AMENDMENT NO. 3

Dated: 9/12/19

**Proposal for: Philadelphia Zoo Animal Hospital and Small Primate Holding
Mechanical Upgrades**

Project No.: 71-19-4365-01

ASK-1

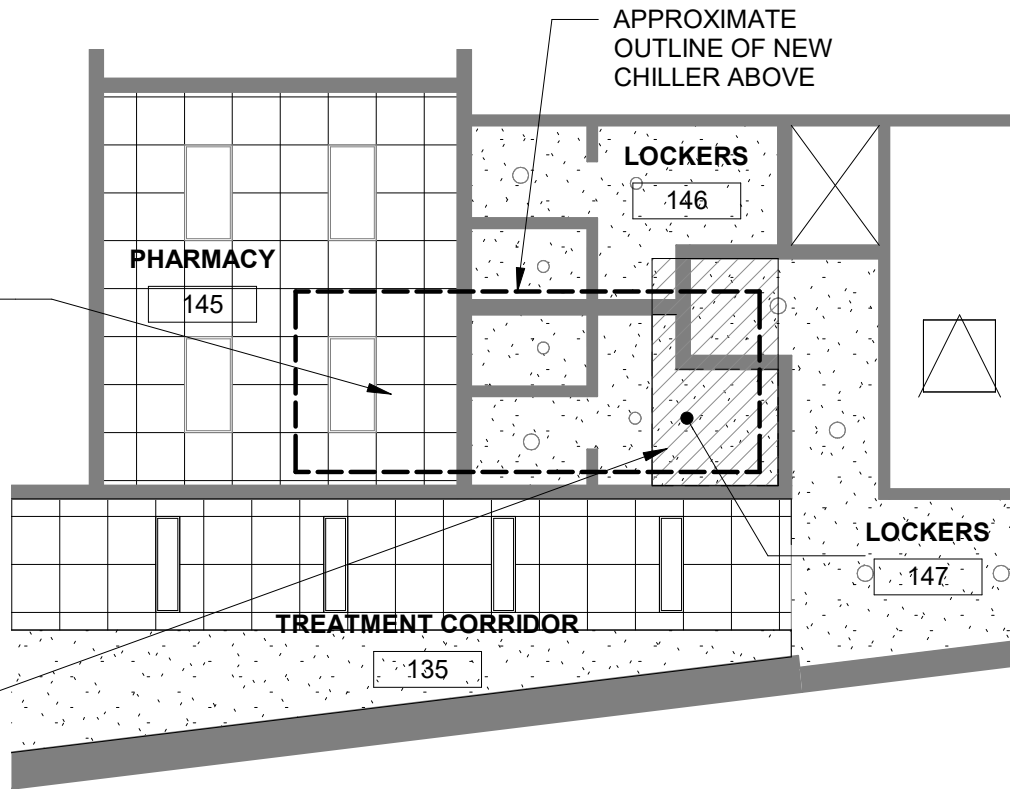
5. Philadelphia Zoo Animal Hospital Mechanical Upgrades: Please see attached sketches ASK-1 and ASK-2 for Partial Reflected Ceiling Demolition and

Construction Plans for the areas beneath the removal and installation of new rooftop equipment dunnage.

CAREFULLY REMOVE AND SALVAGE CEILING TILE, FRAMING, DEVICES, GRILLES/ REGISTERS/ DIFFUSERS, AND LIGHT FIXTURES BELOW AREA OF STEEL DUNNAGE REPLACEMENT FOR REINSTALLATION

REMOVE HATCHED AREA OF EXISTING GWB CLG TO CREATE ACCESS FOR STEEL DUNNAGE REPLACEMENT. REMOVE AND SALVAGE ALL CEILING MOUNTED DEVICES, GRILLES/ REGISTERS/ DIFFUSERS, AND LIGHT FIXTURES FOR REINSTALLATION.

1. SPRINKLER AND FIRE ALARM SYSTEMS TO REMAIN IN CONSTANT OPERATION. FOR ANY CLG WORK WHERE CLG REMAINS OPEN AT THE END OF THE DAY, SPRINKLER HEADS TO BE TEMPORARILY ROTATED UP UNTIL NEW CLG IS INSTALLED.
2. EXTENT OF GWB REMOVAL MAY BE LARGER TO FACILITATE MEANS & METHODS OF WORK.

ASK-2

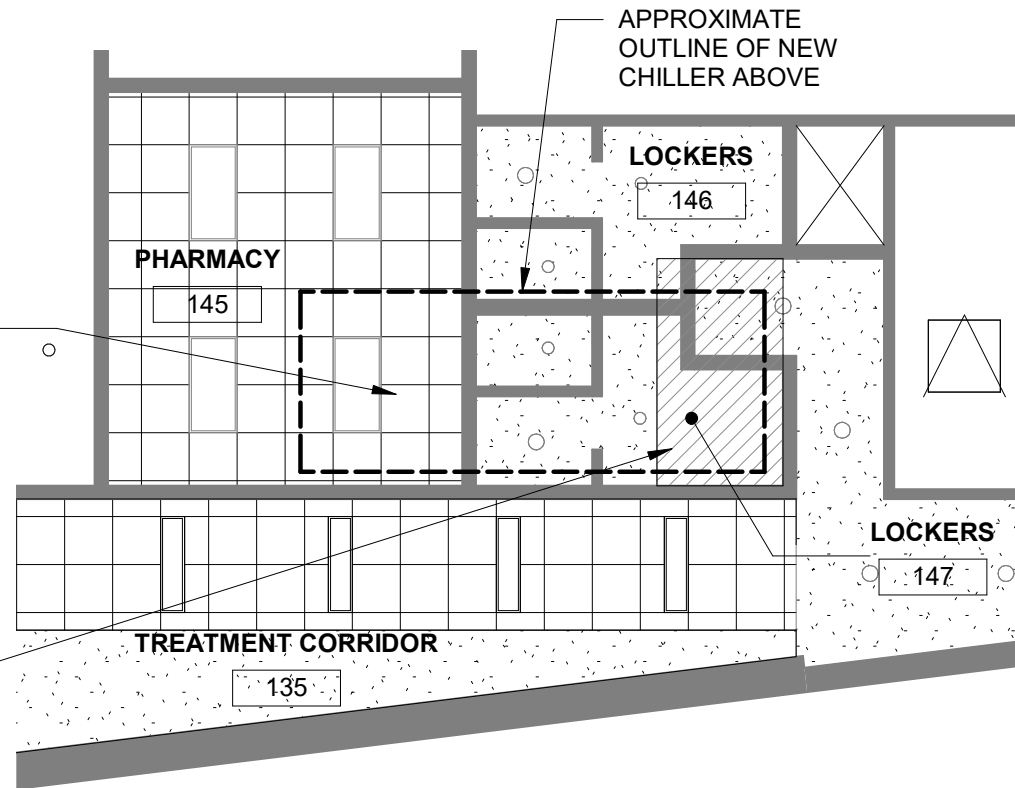
REINSTALL ALL CEILING TILE, GRID, DEVICES, GRILLES/ REGISTERS/ DIFFUSERS, AND LIGHT FIXTURES DISPLACED DURING CONSTRUCTION; REPLACE ANY DAMAGED CEILING TILE OR GRID WITH MATERIAL TO MATCH EXISTING

FURNISH AND INSTALL NEW GWB CLG IN HATCHED AREA - REINSTALL ANY CEILING MOUNTED DEVICES, GRILLES/ REGISTERS/ DIFFUSERS, AND LIGHT FIXTURES DISPLACED DURING CONSTRUCTION - PAINT TO MATCH EXISTING CEILING - CEILING HEIGHT TO MATCH EXISTING AND BE FLUSH

1. SPRINKLER AND FIRE ALARM SYSTEM DEVICES TO BE RETURNED TO ORIGINAL LOCATIONS AND POSITIONS.
